AMENDMENTS TO THE DRAWINGS:

FIG. 1

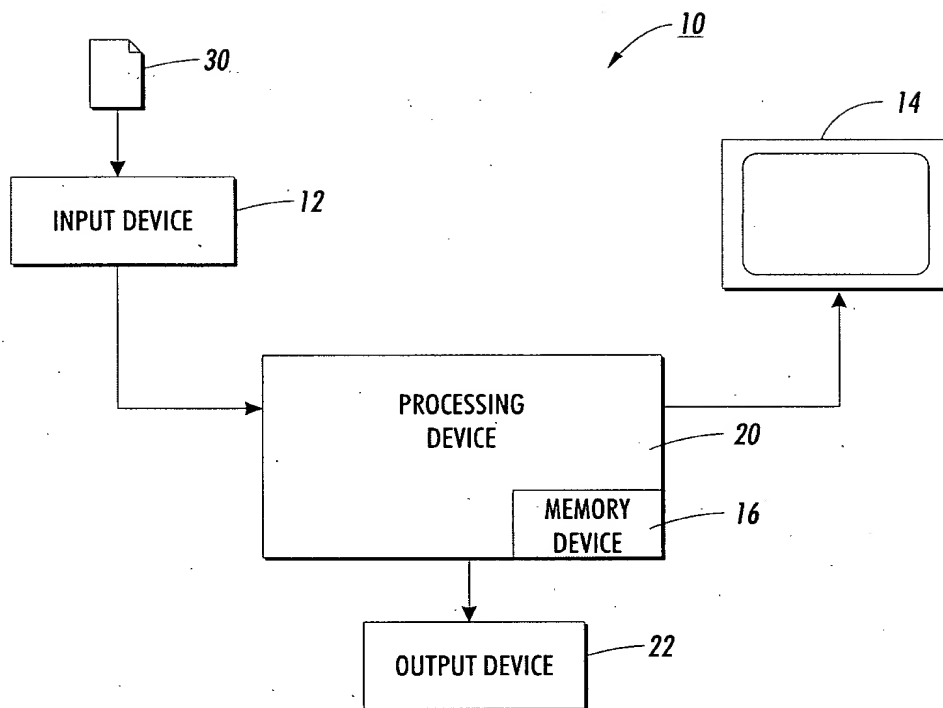
The attached replacement sheet of drawings includes changes to FIGURE 1. This sheet, which includes FIGURE 1, replaces the original sheet including FIGURE 1. In FIGURE 1, the Examiner objected to the drawing because elements 20 and 16 were not labeled as "processing device" and "memory device" respectively. FIGURE 1 has been amended to correct this informality, and Applicants respectfully request that the objection be removed.
